Subject: 10CFR21 Reporting of Defects and Non-Compliance -
Engine Systems, Inc. Report No. 10CFR21-0106, Rev. 0

EMD (Detroit Switch) Temperature Switch – Potential Missing Set Screw

Report No. 10CFR21-0106

COMPONENT: EMD (Detroit Switch) temperature switch – potential missing set screw

TYPICAL EMD/DETROIT TEMP SWITCH
(shown with cover removed)

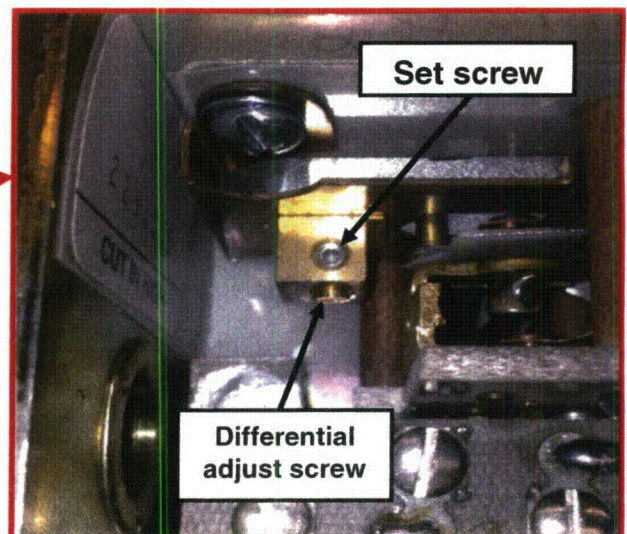
The set screw found in the temperature test fixture oil bath is 1/8" long with #6-32 threads. This is the same length, thread size and style as the set screw used in EMD/Detroit temperature switches to lock the differential adjustment screw.

SET SCREW LOCATION

All affected users should inspect the suspect switches (see Table 1) for presence of the set screw at their earliest convenience. If the set screw is missing, the temperature switch should be returned to ESI for rework.

1. Loosen the screw located in the center of the temperature switch cover.
2. Remove the cover, the mounting screw and cover gasket will remain attached to the cover.
3. Look behind the insulator to access the differential adjust screw.
4. Verify that set screw is installed.
 - a. If installed, re-install the cover; temperature switch is acceptable.
 - b. If not installed, return the temperature switch to ESI for rework.
